# 80C186/188EB and 80C186/188EC SIO Mode 0 Max Baud Rate

This techbit explains that the maximum baud rate for Mode 0 (synchronous) operation of the serial I/O port (SIO) is incorrectly explained in the manuals.

Serial Port Mode 0 Reception of a 055h value

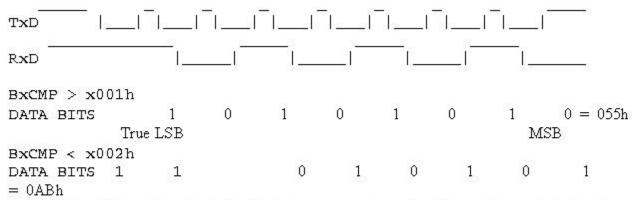
If the device is run at a faster baud rate than when BxCMP à x002h (i.e. BxCMP=x001h), the serial port buffer register (SxBUF) will not **receive** the correct data. The receive shift register is clocked from an internal signal, not from the signal on TxD. Although the two signals are normally synched, when BxCMP = x001h the receive shift register clock puts out **one** clock ahead of, and out of synch with, the first pulse transmitted by TxD. This causes whatever data is on the RxD pin before the reception is actually supposed to begin (i.e., before the first rising edge of the first pulse transmitted by of TxD) to be clocked in as the LSB. Then the reception continues in the normal synchronous fashion except that the data being received is now shifted left once by the false start of the receive shift register and the seventh real data bit is received as the MSB and the eighth data bit or true MSB is never shifted into the receive shift register.

The following timing diagram and explanation show the missed MSB.

False LSB = Extra bit clocked in internally causing the false MSB to = 7th data bit, not the 8th.

If BxCMP = x001h, then the SxBUF register will contain the incorrect data of 0ABh at the end of reception. If BxCMP register greater than or equal to x002h, then the SxBUF register will contain the correct data of 055h at the end of reception. Therefore, x002h is the minimum value for the baud rate compare register.

The serial port in synchronous mode (Mode 0) cannot be operated with the BxCMP register holding a value of less than x002h.
